April 24, 2024

PROJECT NAME: SWEET DIXIE SOUTH RV PARK

PROJECT NUMBER: 2016080002

APPLICATION: MAJOR SITE PLAN #30849

Sheet title:  
COVER SHEET

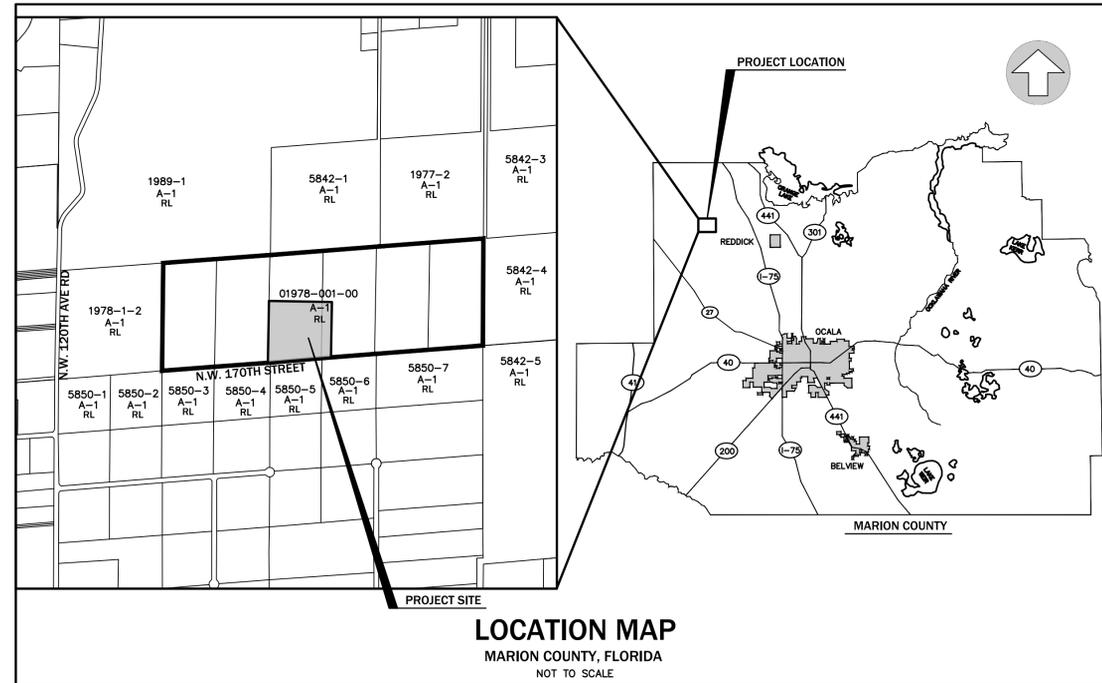
- 32 DEPARTMENT: UTIL - MARION COUNTY UTILITIES  
REVIEW ITEM: Additional Utilities comments  
STATUS OF REVIEW: NO  
REMARKS: Typo on cover sheet - see changemark in ePlans.

- 39 DEPARTMENT: 911 - 911 MANAGEMENT  
REVIEW ITEM: 2.12.8 - Legal description matches boundary on plan  
STATUS OF REVIEW: NO  
REMARKS: Sheet C001 under Legal Description has individual tracts listed. The tracts listed were combined with others to create a new Parcel Account Number. The land that was known as Tracts 4 through 9 are now known as Parcel Account Number 01978-001-00. Please update with the new Legal Description.

Sheet title: MASTER DEVELOPMENT PLAN

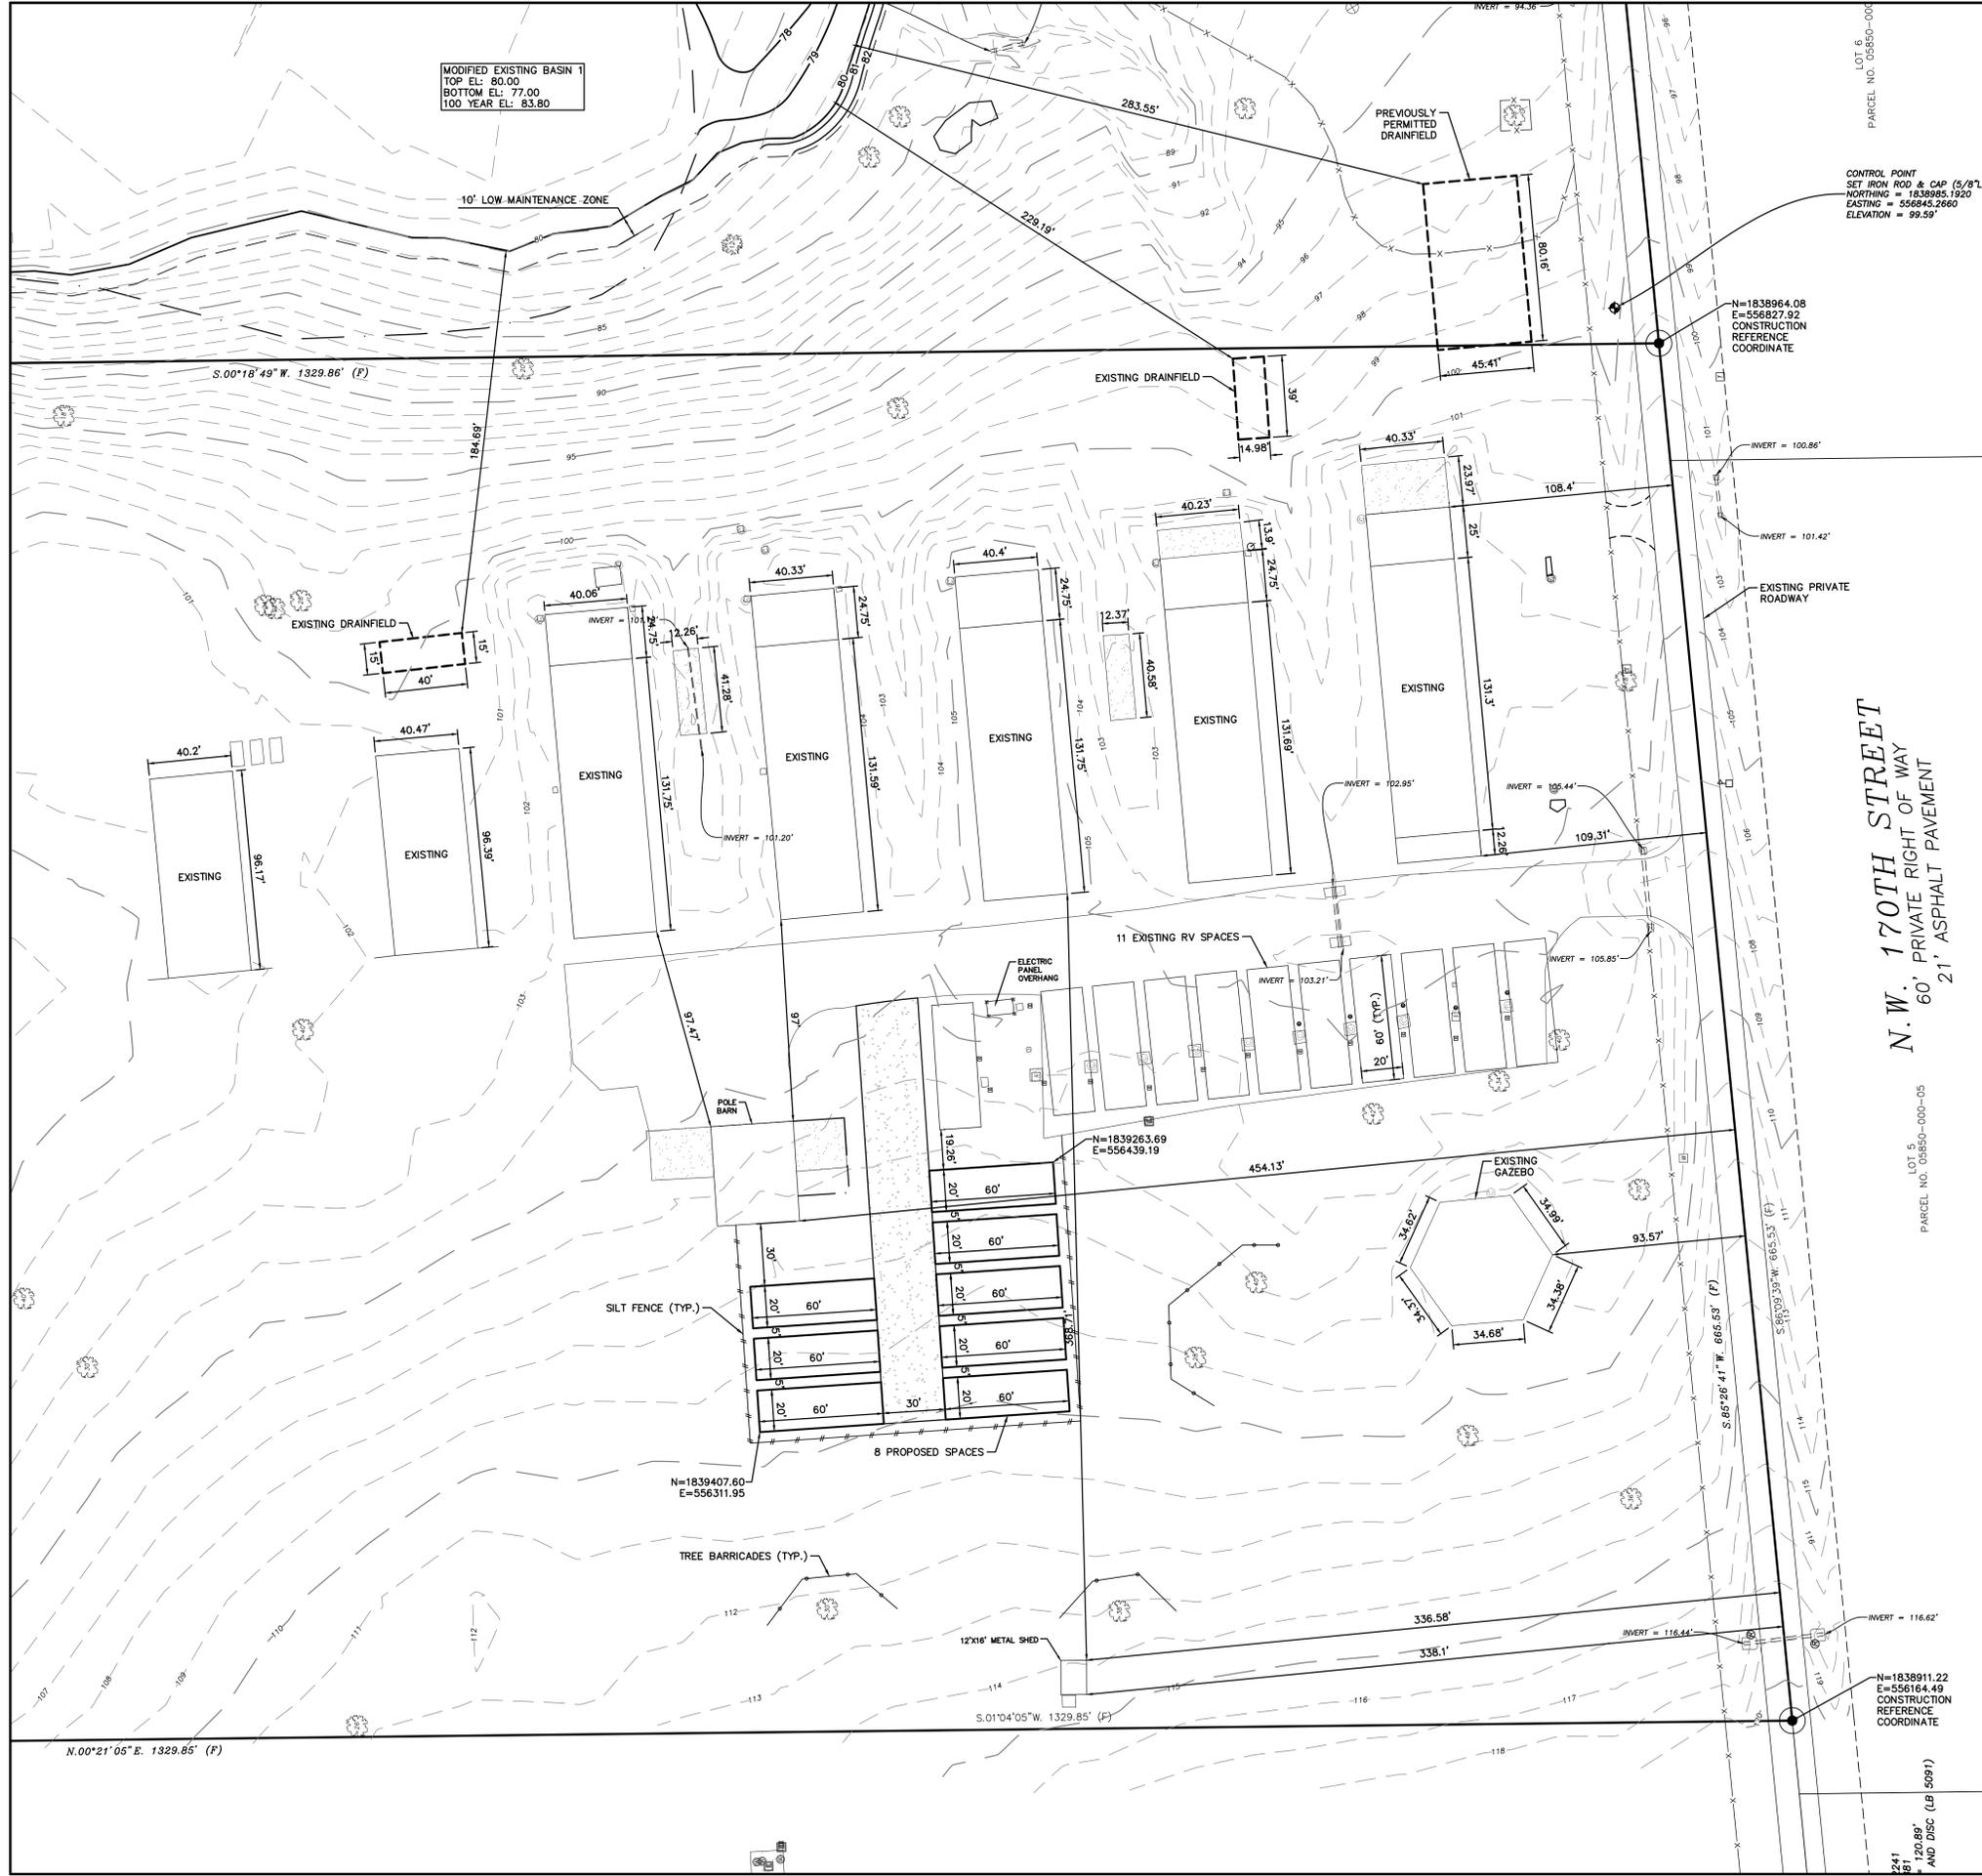
- 40 DEPARTMENT: 911 - 911 MANAGEMENT  
REVIEW ITEM: 2.12.28 - Correct road names supplied  
STATUS OF REVIEW: NO  
REMARKS: Sheet C130 is missing road name label for NW 170th St.

Sheet title: BASIN 1 DETAILS

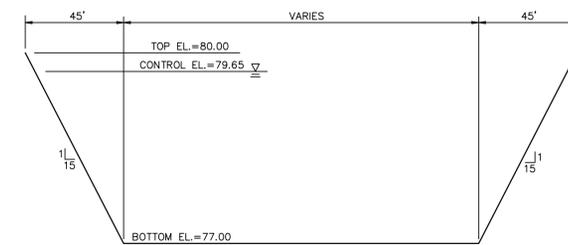
REMARKS: Please provide the recovery calculations to show that the modified DRA recovers with 14 days. If the DRA does not fully recover in the 14 days, the DRA must be designed to retain an additional Post-Pre volume during a second design storm (this is typically a second 100-year 24-hour storm)
